RE: 722 Crossway Rd. Burlingame, CA
Resubmittal with request for alterations to design.

3/27/19

To the Design Counsel Board,

PAGE (3)

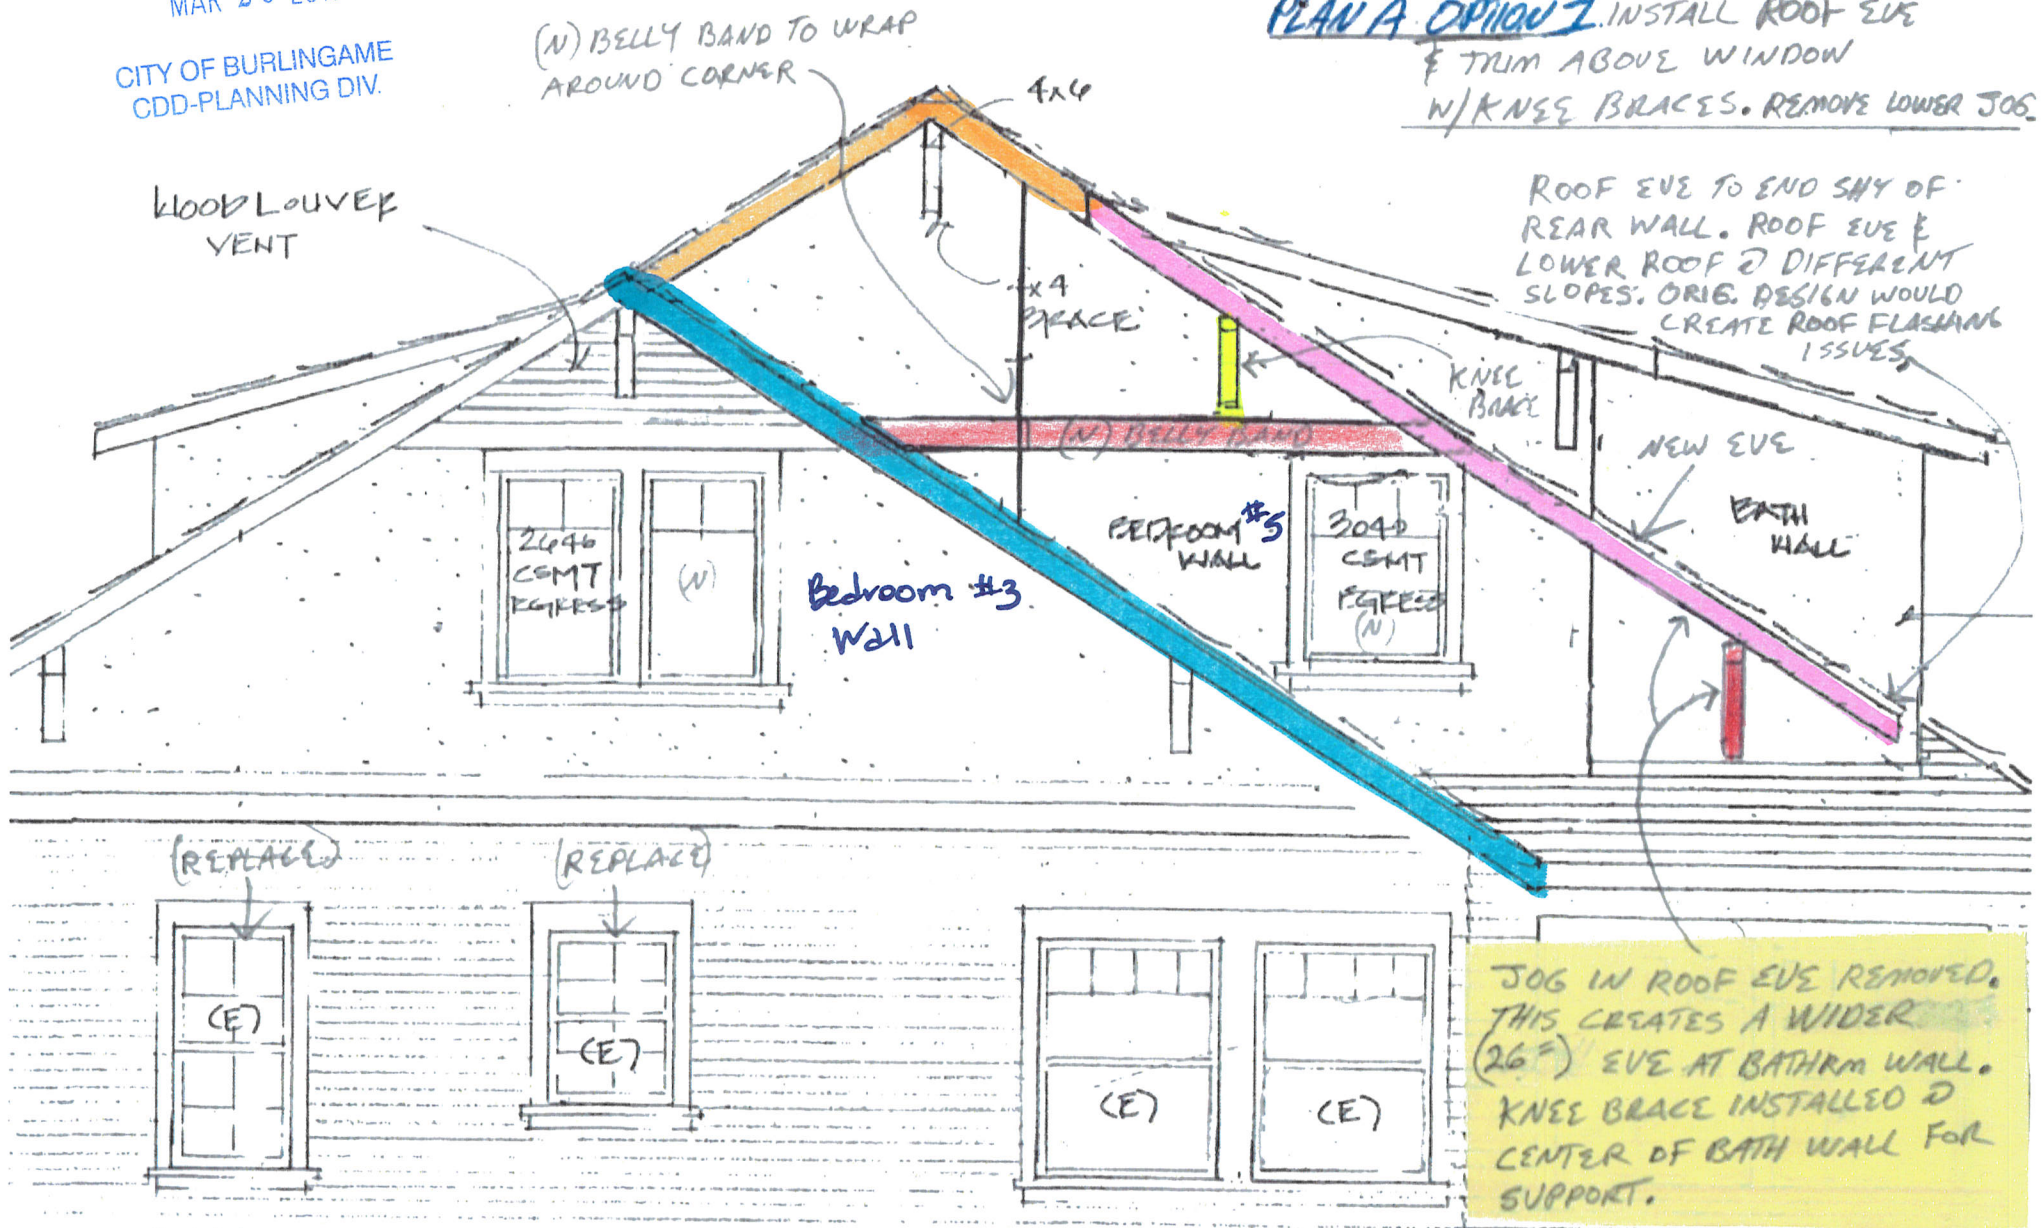
Page (3): Plan A. This detail shows the eyebrow roof eve with additional knee braces and a belly band trim board over the new 36"x 54" casement window. The roof eve @ the bath wall will be wider (24") due to the exterior corner of the bathroom wall. This roof eve cannot end or bury into the lower 1st floor roof, as originally shown, due to different slopes of each roof. This would have also created a roof flashing problem for my roofer who will not guarantee against water penetration if built. I have the new roof eve ending just shy from the edge of the exterior rear corner and ending just above the lower 1st floor roof. Refer to page 3.B

Page (3.A) This plan removes the new roof eve jog that follows the bathroom wall and extends straight. This makes for a wider eve (24"+) and will require a knee brace center of the bathroom wall. This knee brace will match the other knee braces however the top horizontal 4x4 shall be 12" longer. See sketch:

PLAN A. INSTALL ROOF EYE
& TRIM ABOVE WINDOW
N/KNEE BRACES

ROOF EYE TO END SHY OF
REAR WALL. ROOF EYE &
LOWER ROOF @ DIFFERENT
SLOPES. ORIG. DESIGN WOULD
CREATE ROOF FLASHING
ISSUES.

EYE JOG
TO FOLLOW WALL

PLAN C.

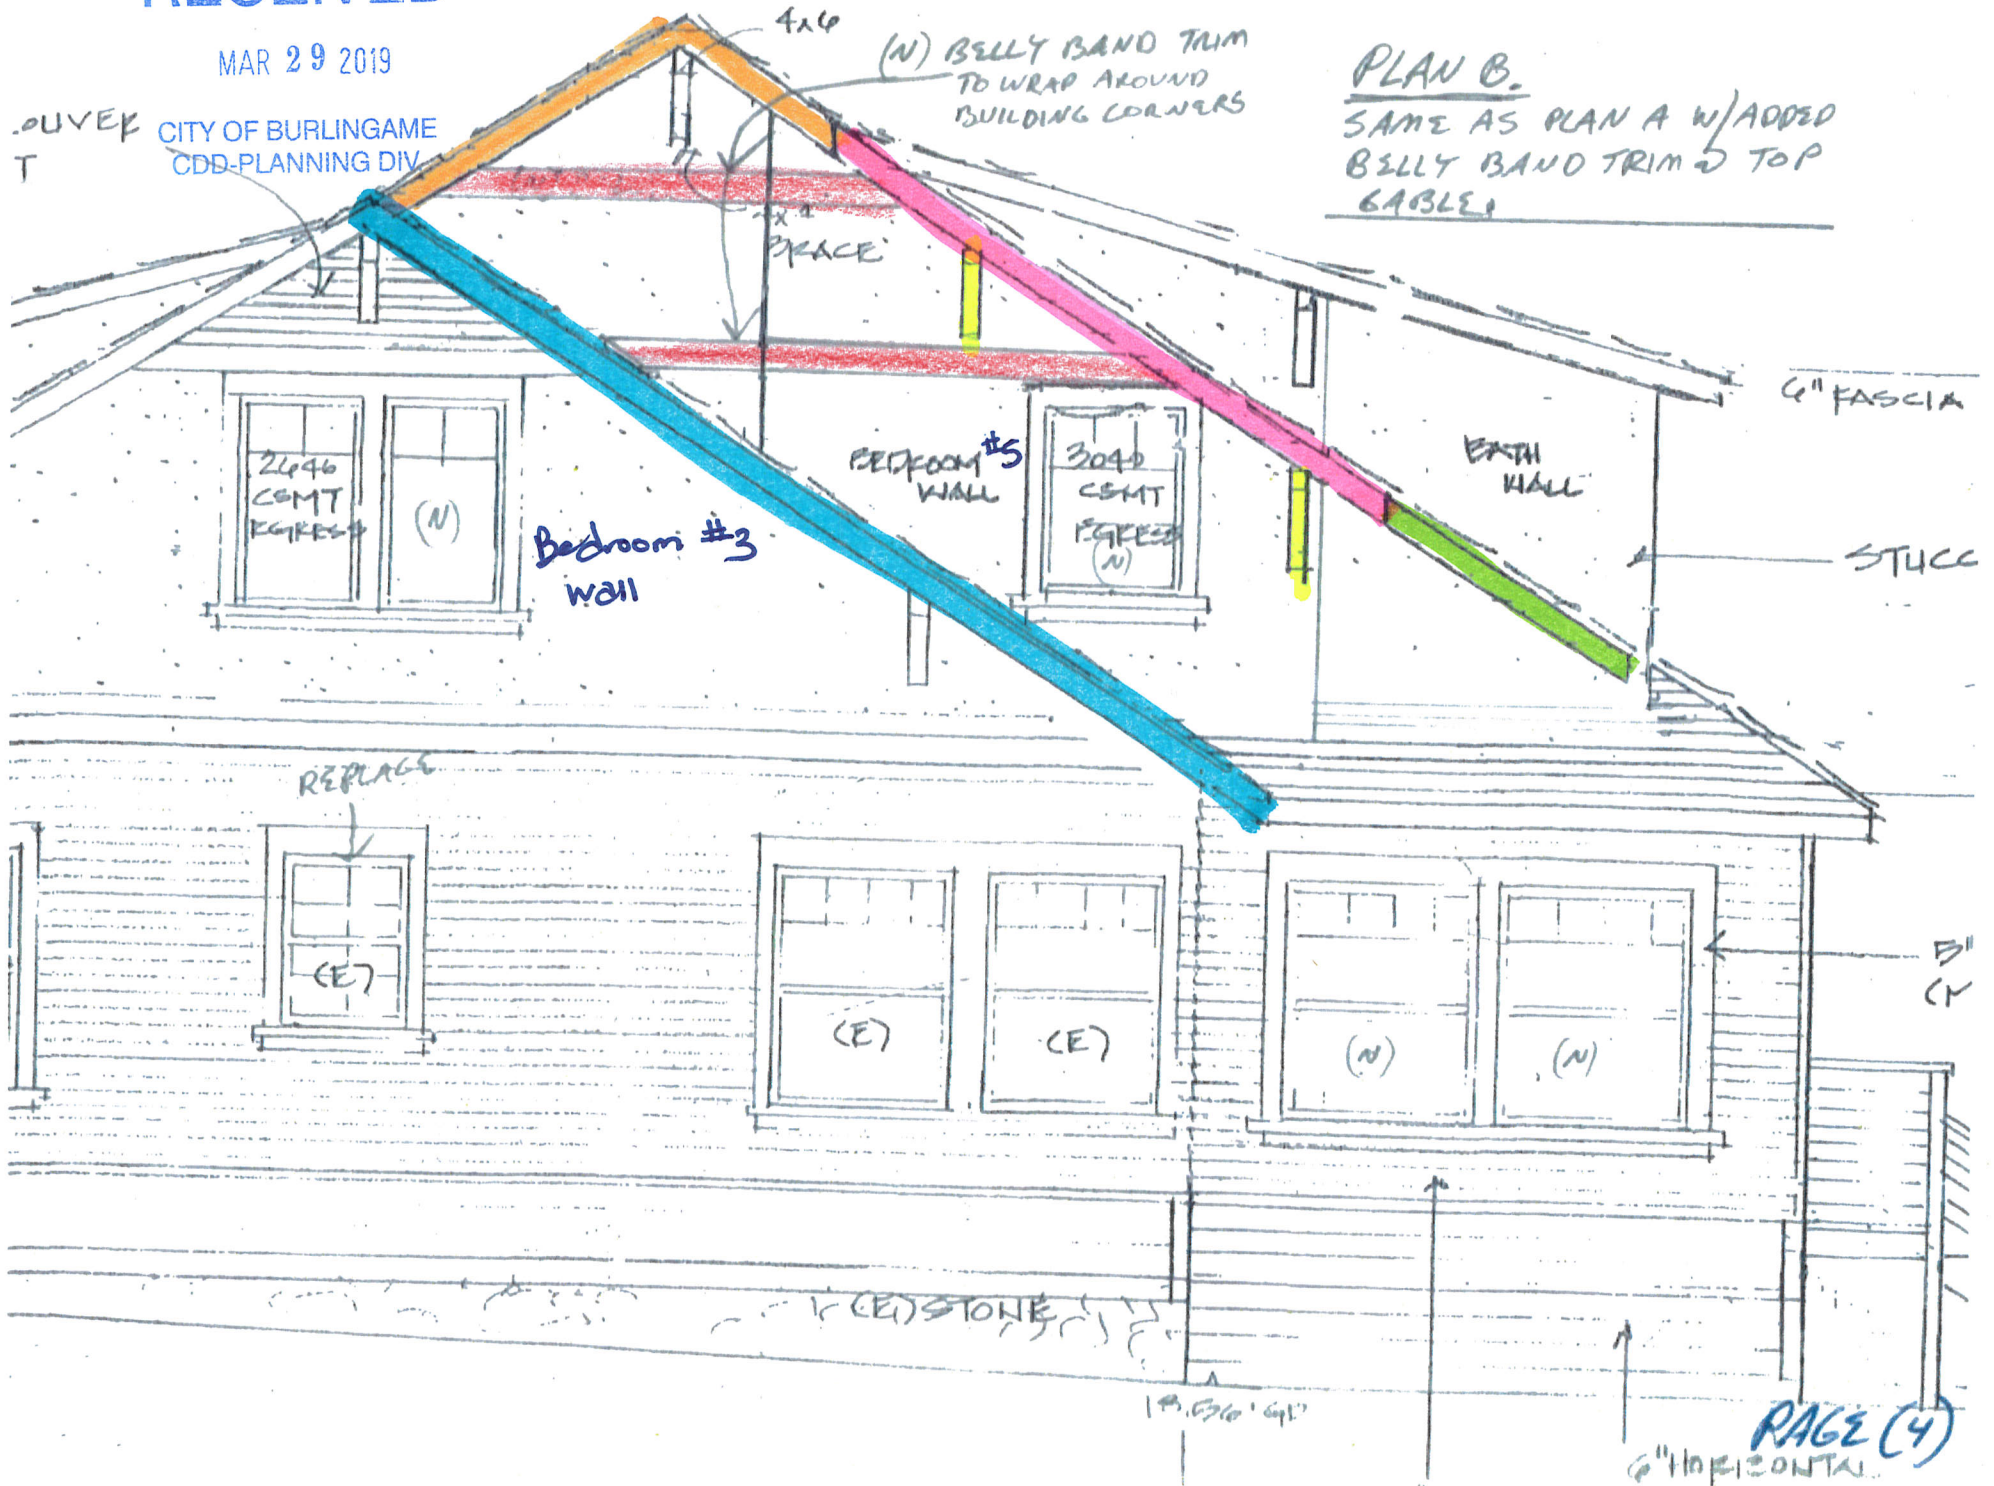
Page (5): **Plan C.** This page shows installing the same elements as the two previous pages and also adding the top gable vent. The vent is shaped as shown because of the exterior corner of the top wall.

INSTAL PARTIAL GABLE
- VENT. CORNER WOULD
AFFECT TRIANGLE SHAPE
